# ADDENDUM #1

**Date:** August 8, 2019  
**City of Brookhaven RFP No.** RFQ 19-315  
**Project Name:** Briarwood Park Pool Project

**This addendum includes project clarifications, plan revisions due to permitting reviews, and responses to questions received by the Deadline for Questions (August 6, 2019 at 12:00 (noon) EST), .**

**1** EXTERIOR ELEVATION - NORTH  
A3.1 1/8" = 1'-0"

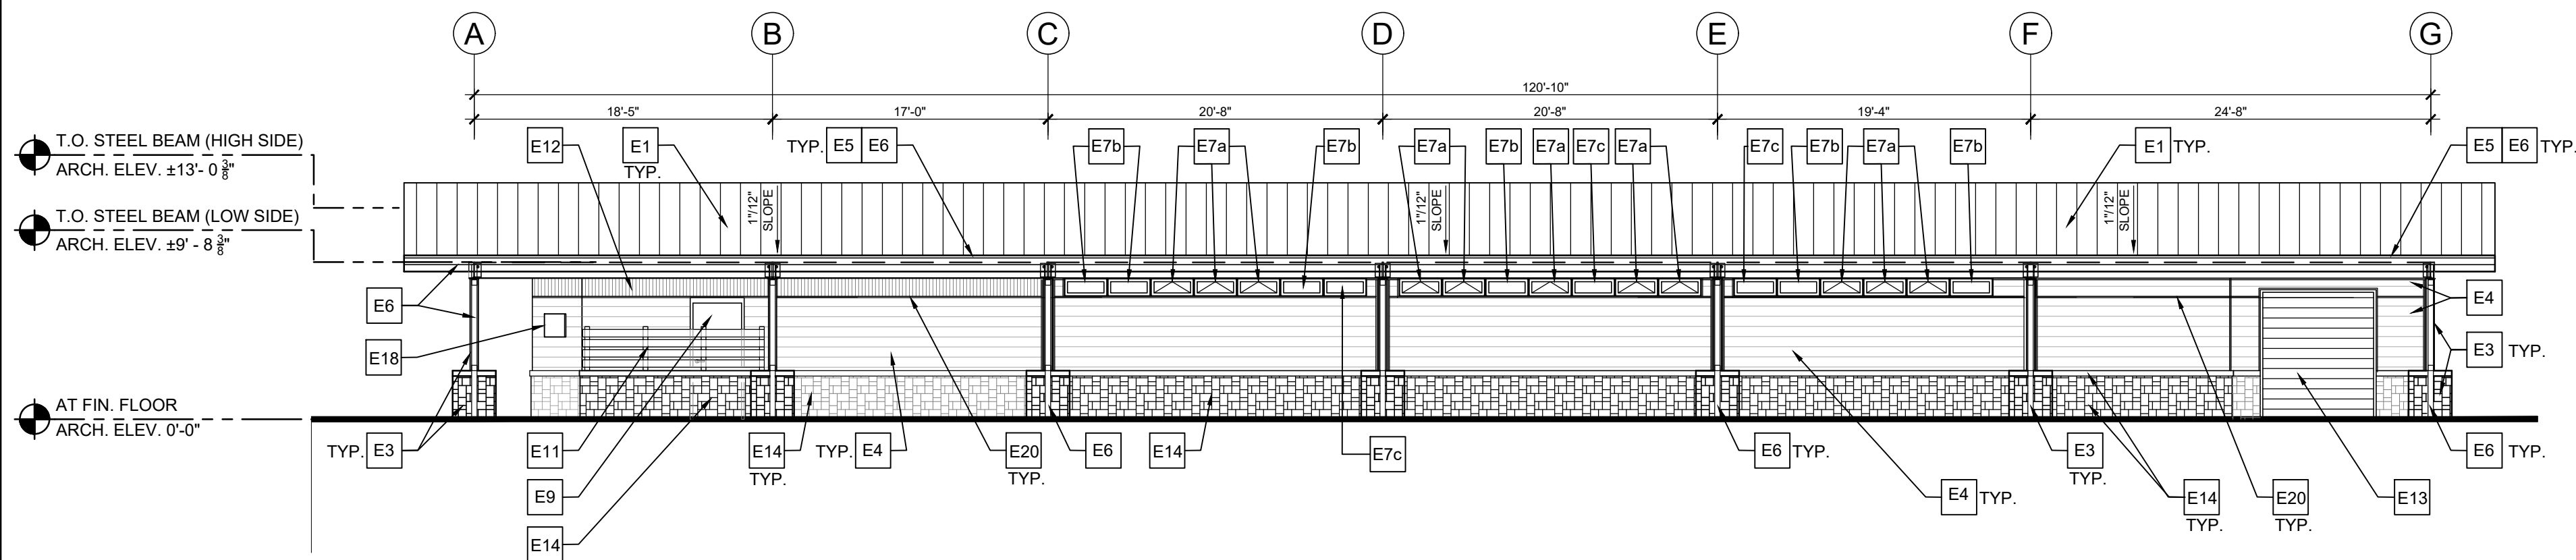
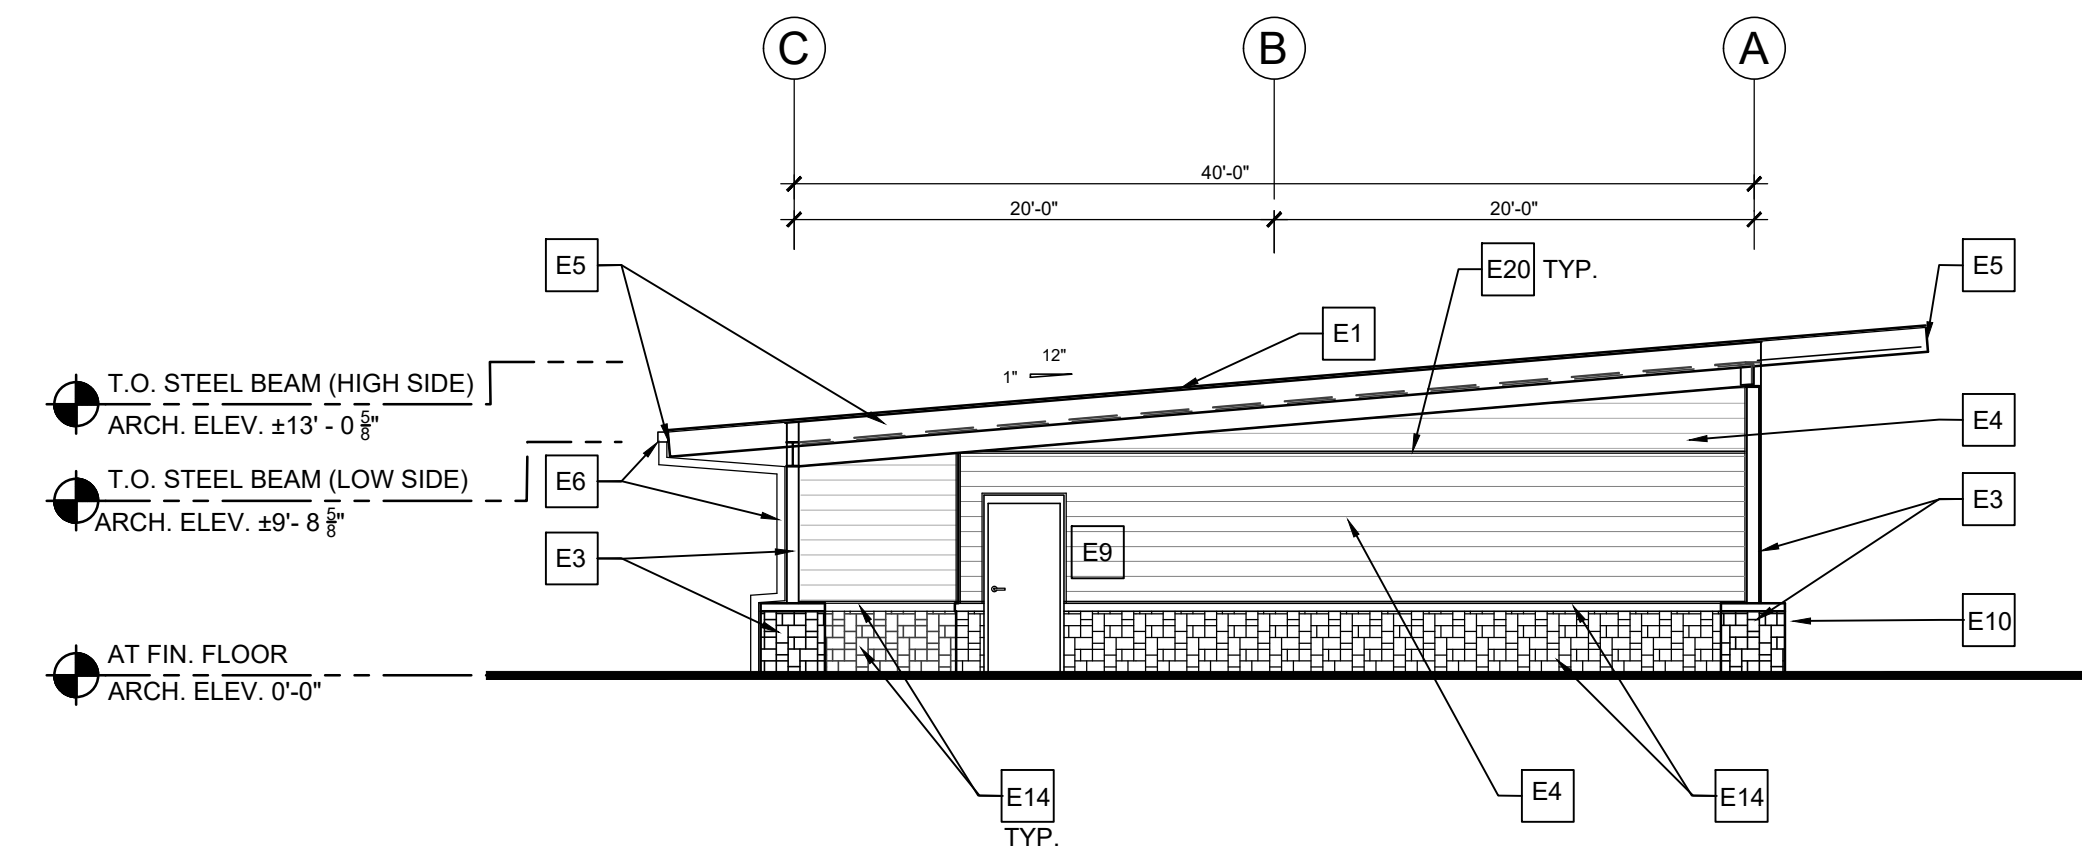
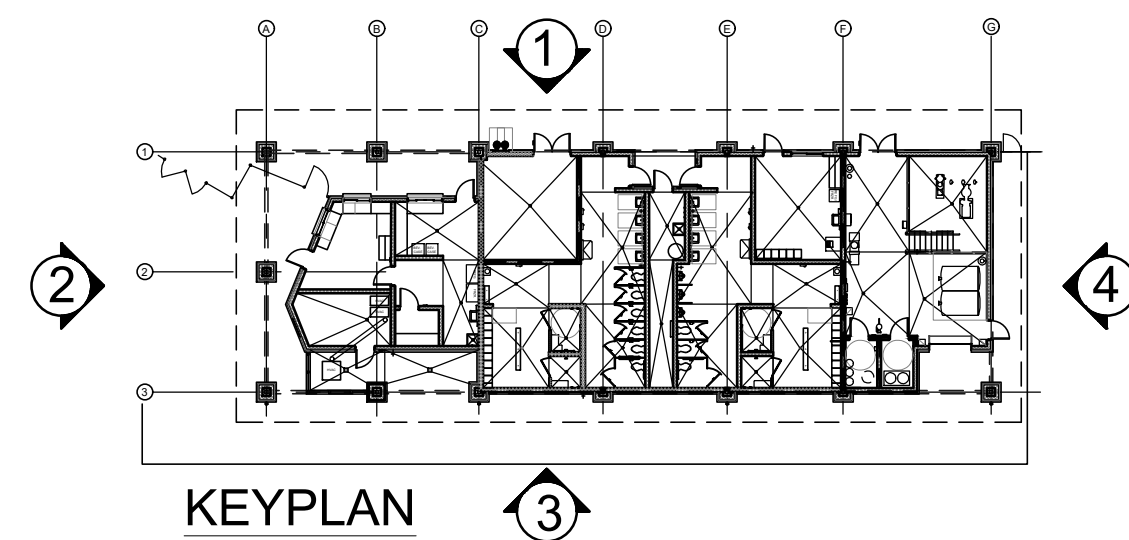
1. The following sheets have been removed and replaced to address a drafting error showing a duplicate water fountain. The revised sheets are noted with **A1 – 08/08/2019 – ADDENDUM 1 REVISIONS**
  - a. A0.4 – CODE REVIEW, COMMCHEC & LIFE SAFETY PLAN
  - b. A2.1 – FLOOR PLAN - DIMENSIONS
  - c. A2.2 – FLOOR PLAN - NOTED
  - d. A3.1 – EXTERIOR ELEVATIONS

- a. *Provide wood fence as referenced on A3.1 - E11 and Detail 2/A4.5. Reference on the Floor Plan on A2.2 that identifies the fence at Outdoor Yard A115 as "Alum. Picket Rail Gate & Fence" is incorrect.*
